Brickland Composite Ltd. (Relocated)

26 December 2023

Structural Inspection Report

Observation-4: Undocumented toilet blocks (Shed-1).

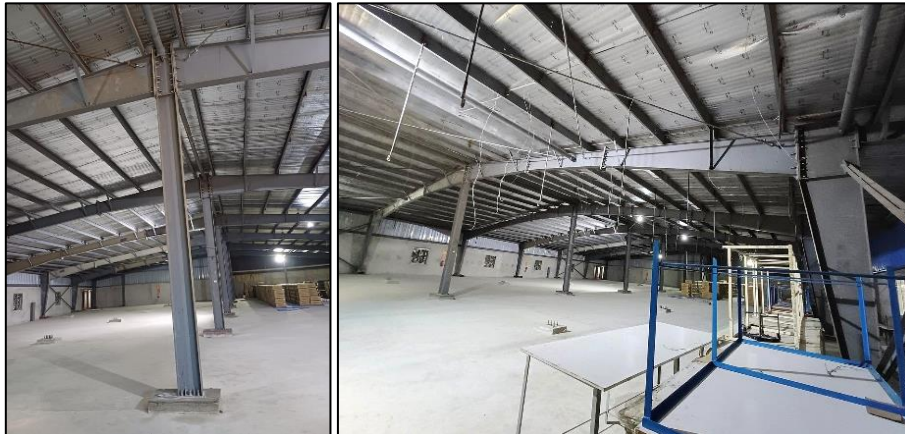
Description: Two toilet blocks were found onsite having no structural details. Prepare necessary as-built drawing with connection details for the toilet blocks.

4.	Missing anchor bolts nut (Shed-1).	The building engineer is required to install missing nuts.	within 6 weeks
5.	Undocumented toilet blocks (Shed-1).	The building engineer required to prepare accurate as built drawing with connection details.	within 6 weeks
